**Amendments to the Drawings**

### **REMARKS/ARGUMENTS**

FIGURE 2C

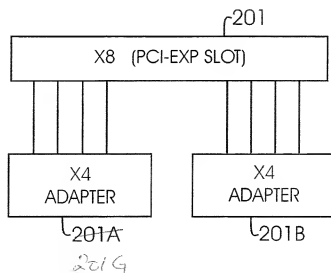
5 The attached sheet of drawings includes changes to Figs. 2C. In Fig. 2C, reference number  
“201A” has been replaced by “201G”. This amendment is in conformity with the description of  
the drawings in the specification. No new matter has been added.  
Acceptance of the amended drawing (Fig. 2C) is respectfully requested.

In amended Figure 2C, reference number “201A” has been replaced by “201G” to bring the drawings in conformity with the specification. A copy of annotated sheet along with re- placement sheet is enclosed.
